#### DEPARTMENT OF HEALTH SERVICES

EMBARCADERO COVE - REVISIONS TO THE PROPOSED PHASE II REMEDIAL INVESTIGATION WORKPLAN AND PROJECT STATUS

### **ERM-West**

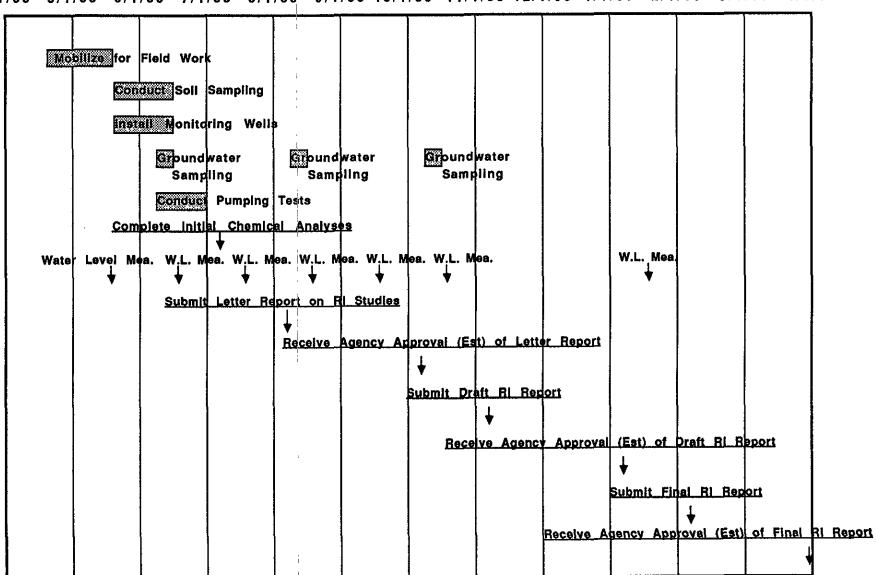
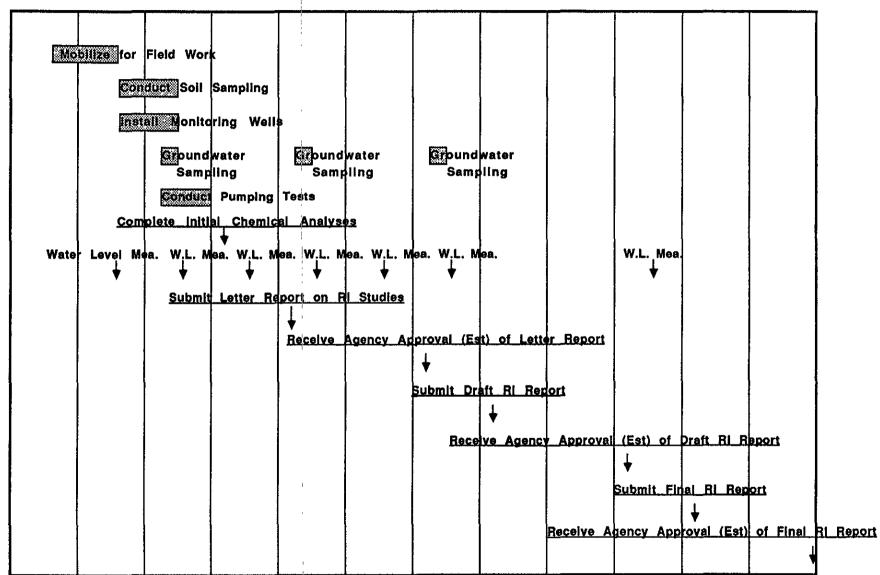
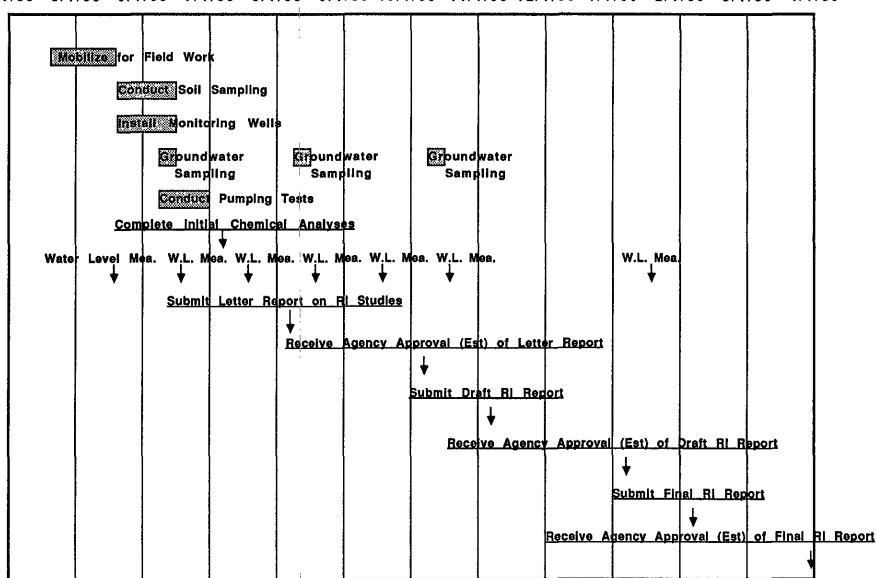
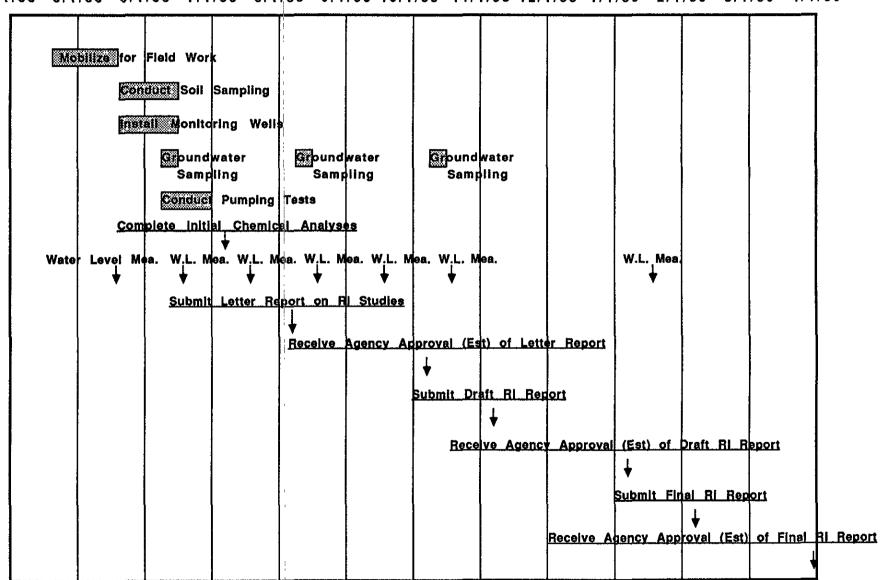
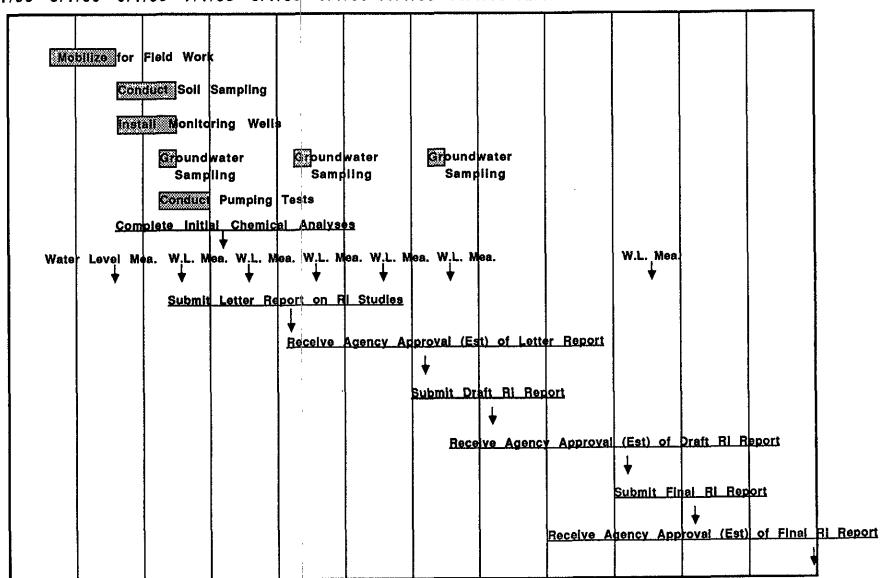
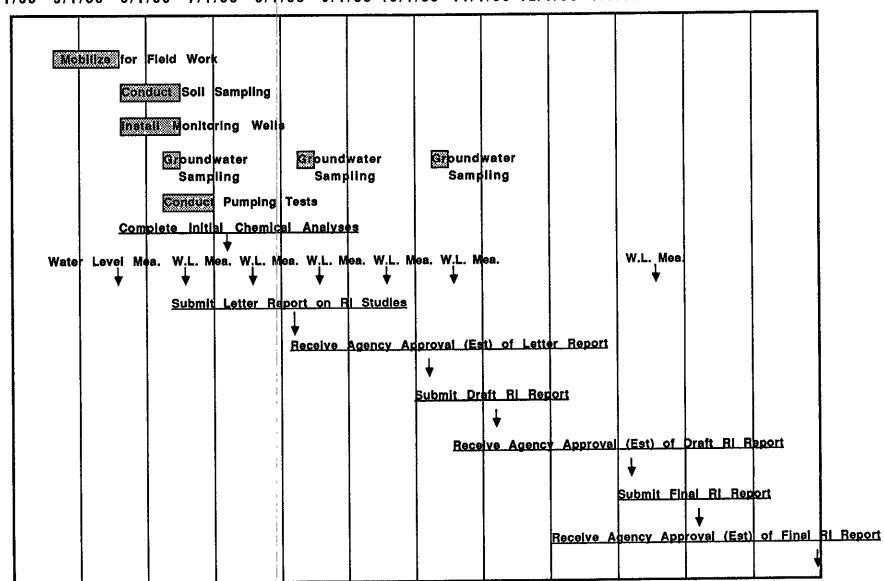
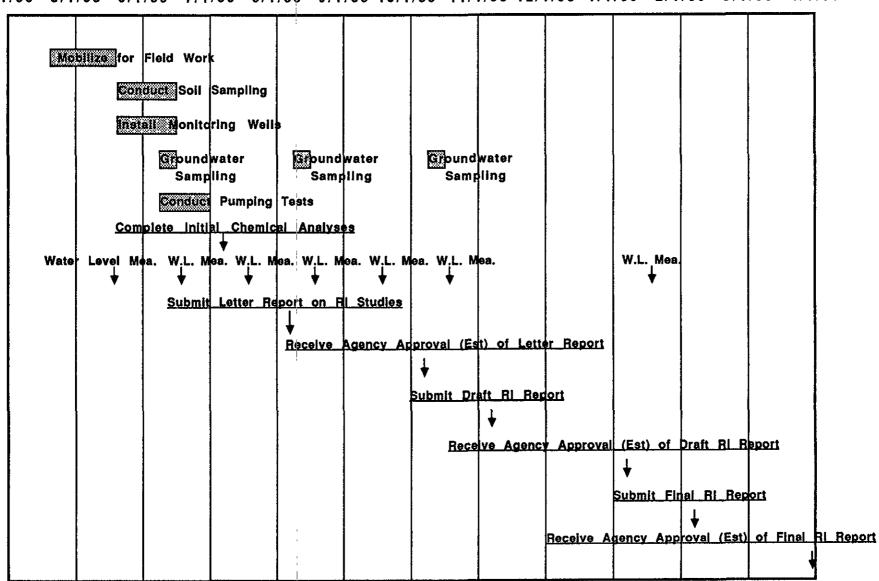
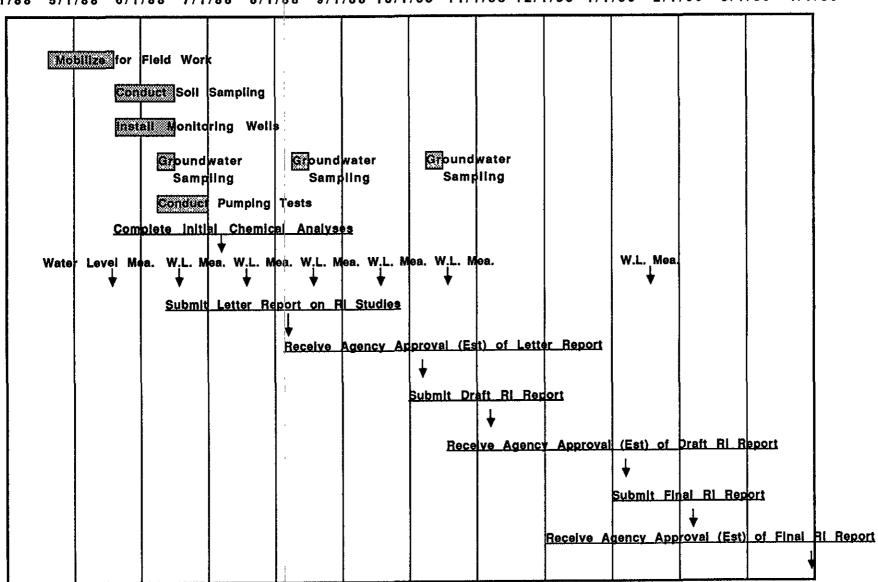
#### 2. <u>Proposed Schedule (Table 6-1)</u>.

- a. The text of the workplan proposes sampling of groundwater monitoring wells every two months for the first six months. Please add these sampling dates to Table 6-1.
- b. As required by Section V.D of the Remedial Action Order, submittal of reports which have been revised in response to comments provided by the Department are required within thirty days of receipt of the Department's comments. Table 6-1 should be revised to reflect this fact.
- c. To make the schedule easier to interpret, please revise and resubmit the schedule using monthly dates, rather than quarterly dates, on the horizontal axis of the table. The revisions should reflect the actual start work date for field activities.

Several improvements have been made to the workplan schedule (Table 6-1). Monthly dates are used to make the table more readable. It is now based on a project implementation date of April 18, 1988 with field work scheduled to begin one month later. Sampling dates for the groundwater monitoring wells have been added. Finally, the time interval for resubmittal of reports in response to the Department's comments has been shortened to thirty days.
